CITY OF SACRAMENTO PLANNING COMMISSION
1231 "I" STREET, SUITE 200, SACRAMENTO, CA 95814

APPLICANT <u>Morton & Pitalo, Inc., 1430 Albambra Boulevard, Sacramento, California 95816</u>		
OWNER <u>Florn Investment Co., P.O. Box 255009, Sacramento, California 95865</u>		
PLANS BY <u>Morton & Pitalo, Inc., 1430 Albambra Boulevard, Sacramento, California 95816</u>		
FILING DATE <u>October 30, 1990</u>	ENVIR. DET. <u>Negative Declaration</u>	REPORT BY <u>CG</u>
ASSESSOR'S PCL. NO. <u>117-0211-011, 014, 023</u>

PROPOSAL: The applicant is requesting the necessary entitlements to subdivide one parcel into 65 parcels to develop 62 single family residences.

P90-420

TENTATIVE MAP

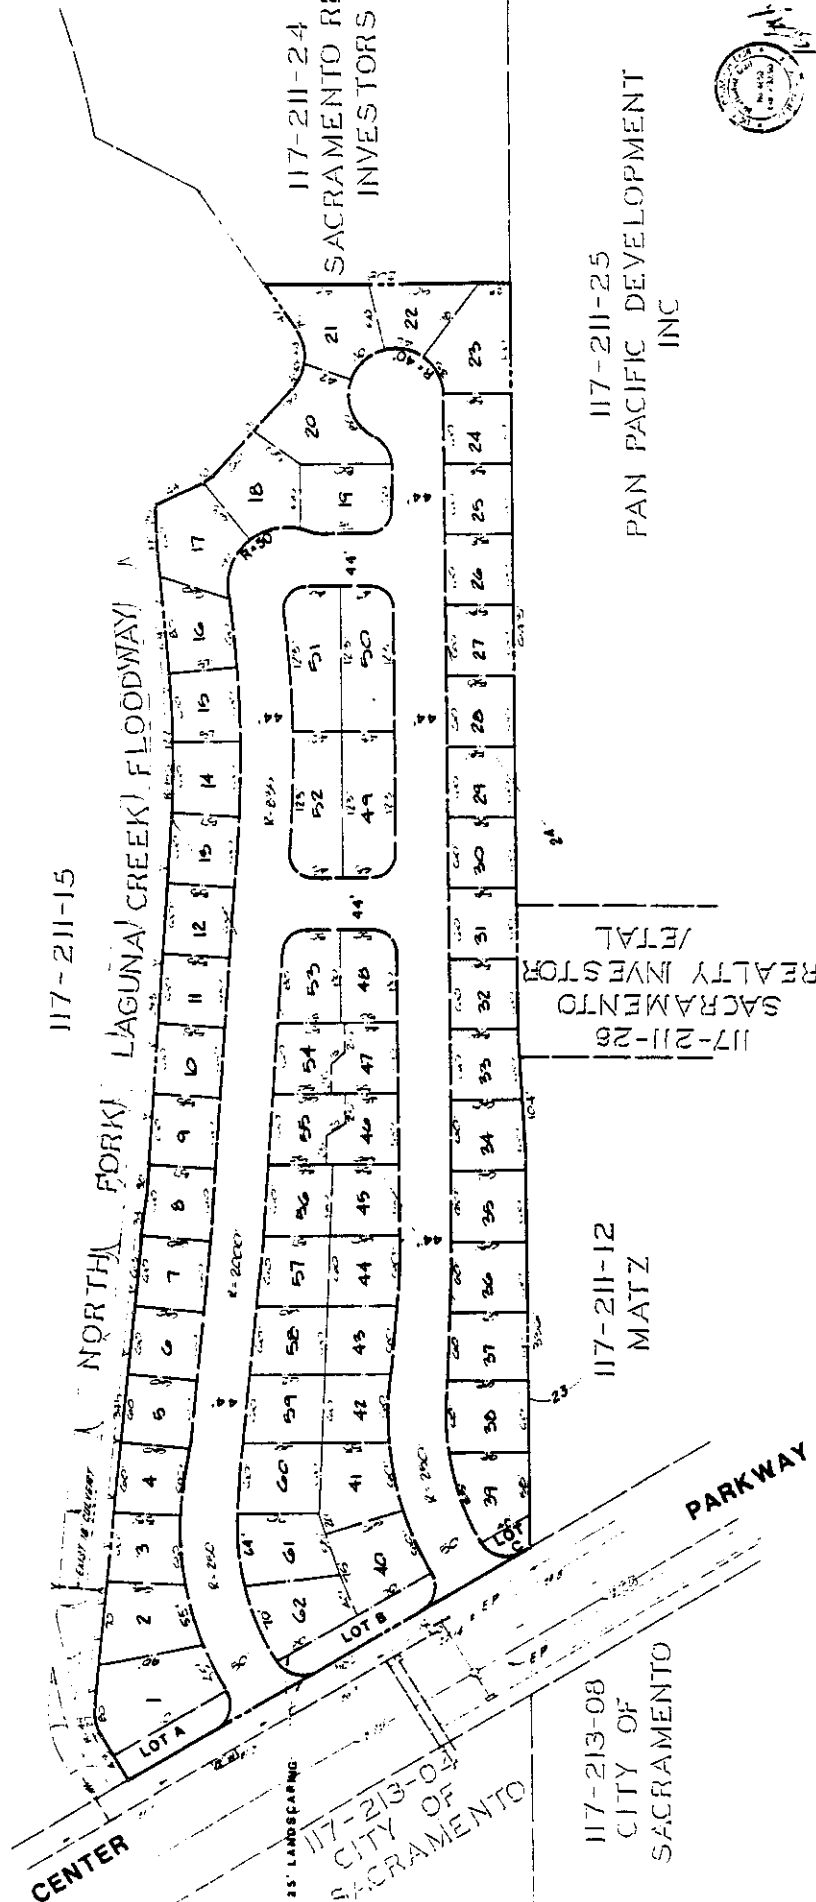
Staff recommends denial of the proposed tentative map for a single family subdivision due to its inconsistency with the multiple family zoning and plan designations of the site.

1. Provide standard improvements pursuant to Section 40.811 of the City Code. Access from Center Parkway will be limited to right turns in and out only. Both access streets shall intersect Center Parkway at 90 degrees to the satisfaction of the Traffic Engineer and shall be a 50 foot right of way for a minimum of 200 feet east of Center Parkway;
2. The applicant shall construct all remaining improvements of Center Parkway adjacent to this parcel including median islands and roadway west of median islands;
3. Submit a soils test prepared by a registered engineer to be used in street design;
4. Prepare a sewer and drainage study for the review and approval of the City Engineer;
5. Sewer may require offsite extensions and oversizing. Storm drainage discharge of locations shall be approved by the Department of Public Works;

1. Center Parkway will have medians blocking left turn into and out of the proposed development.
2. All streets shall intersect at 90 degrees for a minimum length of one-half street width plus the radius of the curb return.
3. The proposed street intersecting with Center Parkway shall be 50 foot right-of-way width for a minimum of 200 feet east of Center Parkway.
4. Driveways shall be a minimum 20 feet long.

Dedicate a standard 12.5 foot public utility easement for underground facilities and appurtenances adjacent to all public ways.

Noise levels received on the proposed property (lots 1, 61, 40, and 39) should conform to Ldn levels specified by the Noise Element of the Sacramento City General Plan (future Center Parkway traffic noise source).

1. Written agreement by the developers to be bound to the latest Elk Grove Unified School District impaction fees as adopted by Board of Supervisors.
2. Traffic control on Center Parkway to minimize left turn movements.
3. Pedestrian/bicycle way between lots 21 and 22 to reduce vehicular requirements for children attending school.
4. Home Owner's Association maintenance agreement for front yards to promote uniform treatment of yards so tightly packed.

- B. A 6 foot high noise barrier shall be constructed along the property line on Center Parkway. The barrier should extend along the west property lines of lots 1, 61, 40, and 39. Specifically, for lots 1 and 39 the wall must begin at the front set back and wrap around the rear lot lines for a minimum of 15 feet.
